8. REPORTS FROM OFFICERS

8.1 Ingleburn CBD Planning Proposal - Post Exhibition Report

Property Description: Ingleburn CBD

Applicant: Campbelltown City Council

Figure 1: Previous Amalgamation Scenario

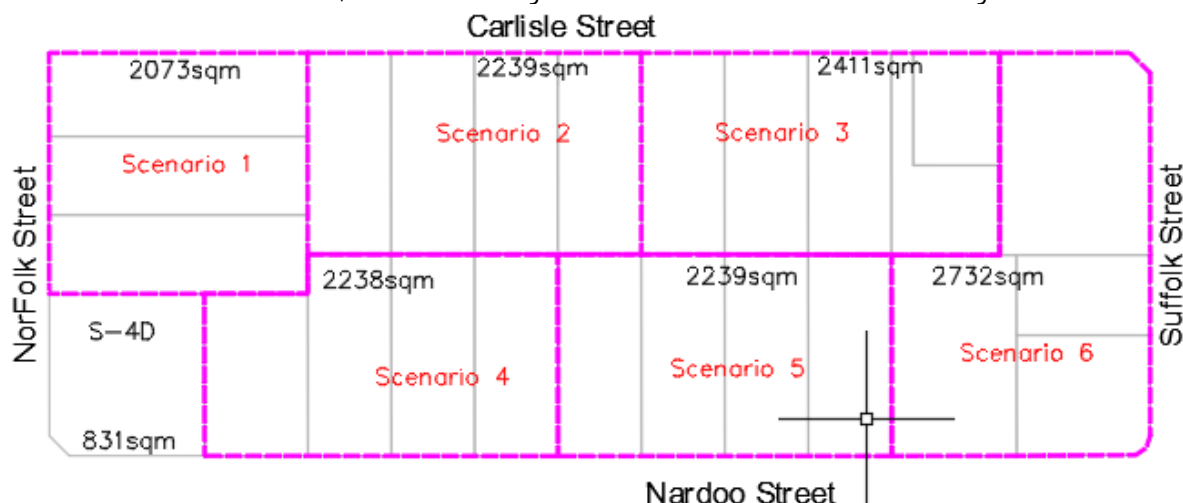
The submissions raised concern with the number of lots that would need to be amalgamated to achieve the required 2000 m². In most instances, at least 4 lots would need to be amalgamated to achieve this proposed outcome as shown on Figure 1 above.

As seen in the plan above Figure 1, amalgamating 4 lots will result in site areas well above the required 2000 m². The proposed area of 2000 m² was selected for 2 main reasons:

1. It is achievable where 4 lots are amalgamated;
2. It is considered an appropriate size for high rise flat buildings as it would enable better design outcomes. A site of this size would accommodate various design layouts such as, courtyards and/or L-shaped layouts, which would maximise solar access, natural ventilation, and deep soil planting and communal open space at ground floor level.

Figure 2: Revised Amalgamation Scenario

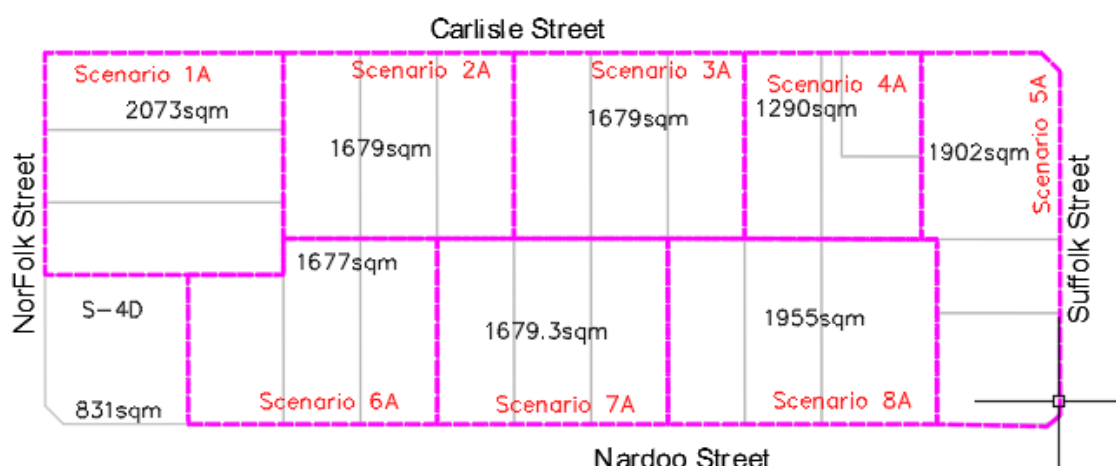
A further analysis in relation to the outcome of amalgamating 3 sites instead of 4 sites was undertaken and is shown below:

By reducing the number of lots that needed to be amalgamated to 3 lots instead of 4, as shown Figure 2 above, the following is noted:

Figure 5: The Lot within the R3 Zone to be partially rezoned to R4

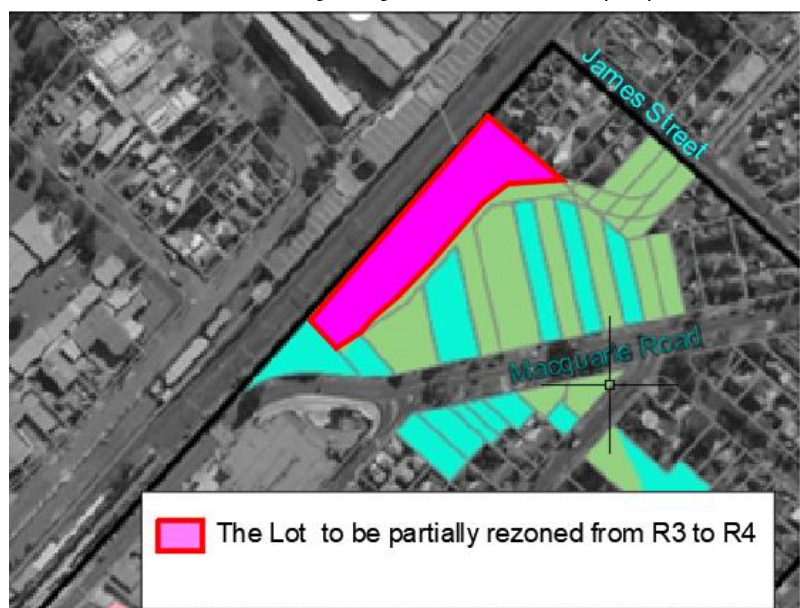
- For lots currently zoned R3 medium density – these lots will be able to be developed for medium density under the current development standards under the CLEP 2015.
- One part parcel (lot 2 in DP859601), as shown on Figure 5 is proposed to be rezoned from R3 to R4, as publicly exhibited, with a maximum building height of 26 m. The proposed

building height will only be able to be achieved where this lot is able to demonstrate safe evacuation routes for pedestrian and vehicles. Safe access/egress can only be achieved in this situation where this lot is amalgamated with at least one additional lot fronting James Street. The maximum building height for this lot is proposed to be 15m. Notably, Council will not support any increased density on any lot within Ingleburn CBD, unless it can be demonstrated to Council's satisfaction that safe evacuation routes can be

obtained for occupants/pedestrian and vehicles.

Figure 11 Lots exposed to H5 or H6 hazard at the peak of the PMF (Green)

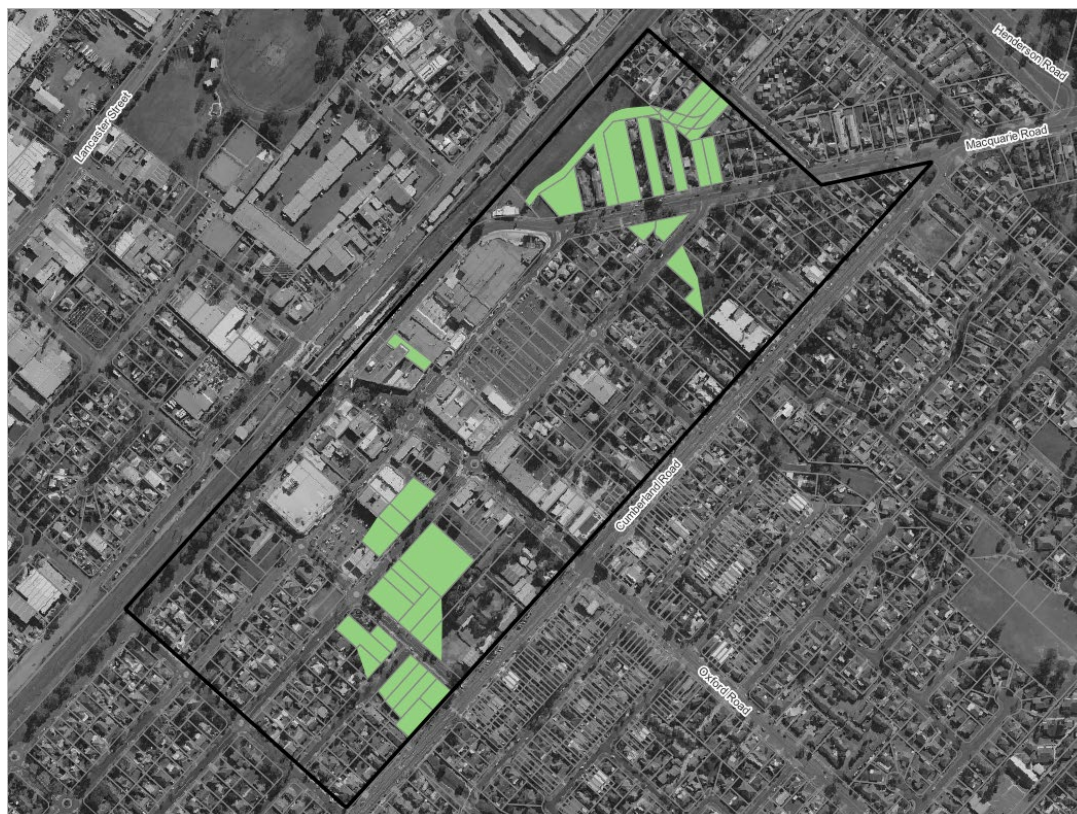
The SES also expressed concerns regarding inclusion of lots exposed to H5 and H6 hazard in the PP as there is potential for structural damage to buildings. Therefore, CSS analysed the flood hazard at the peak of the PMF to identify lots exposed to high (H5 or H6) hazard conditions that should be excluded from the PP. These lots are identified in green in Figure 11.

Figure 14 Lots that could be potentially consolidated to overcome evacuation limitations (no drainage upgrades)

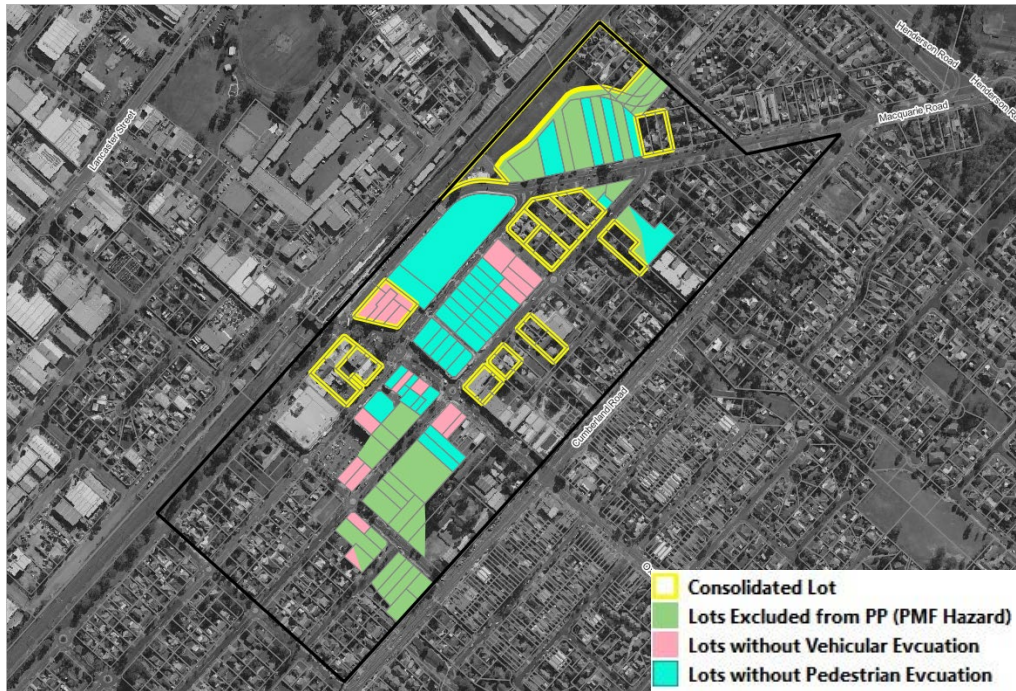
Council and DPE:EHG noted that there were opportunities for evacuation difficulties to be overcome if some lots were consolidated with adjacent lots that had access to low hazard evacuation routes. Therefore, a review of the lots with evacuation difficulties identified in Figure 12 and Figure 13 was completed to identify lot consolidation opportunities.

The outcomes of this assessment are presented in Figure 14 (no drainage upgrades) and Figure 15 (including drainage upgrades).
